**CITY OF MOUNTAIN VIEW****ENVIRONMENTAL PLANNING COMMISSION  
STAFF REPORT  
MARCH 15, 2017****5. PUBLIC HEARINGS****5.1 Study Session to Discuss Proposed General Plan and Zoning Map Amendments for a Residential Development Consisting of a 348-Unit Addition to an Existing 402-Unit Apartment Complex with Three New Underground Parking Garages and a 1.48-Acre Public Park (Dedicated to the City) at 555 West Middlefield Road****RECOMMENDATION**

That the Environmental Planning Commission (EPC) provide input on the proposed residential development at 555 West Middlefield Road.

**Figure 4 – Street Facade and Corner Massing, Lot 1**

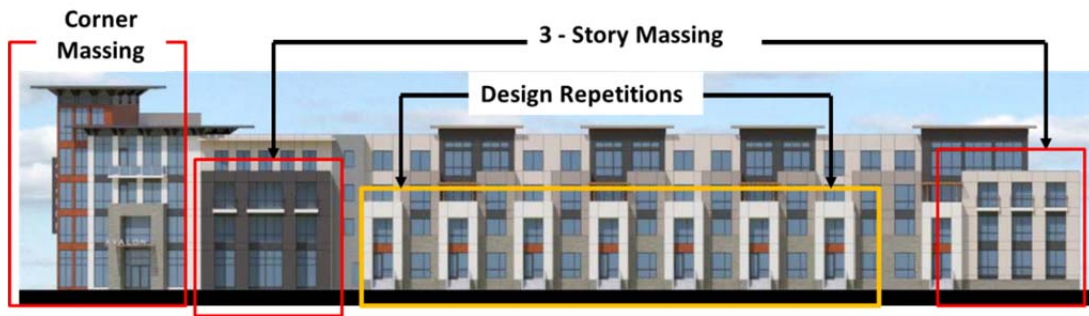
The R4 design guidelines provide direction to maintain appropriate scale and pattern of development that is compatible with existing neighborhoods. As shown below, the proposed four-story building includes two- and three-story elements closer to the street. However, taller elements need better pedestrian-scaled features, and the proposed materials (currently ledgestone and fiber cement panels) should provide a warmer, residential character.

Staff will continue to work with the applicant on features that promote integration with the surrounding lower-density residential area and adjacent on-site buildings, including: porches, entries, and bay features to establish a strong relationship with street frontages and to emphasize more pedestrian-scale elements; upper floor step backs and other design elements to deemphasize taller massing; variation and breaks in long facades; and color/material palettes to provide a more current/updated residential character while better integrating with the lower-density area surrounding the project site.
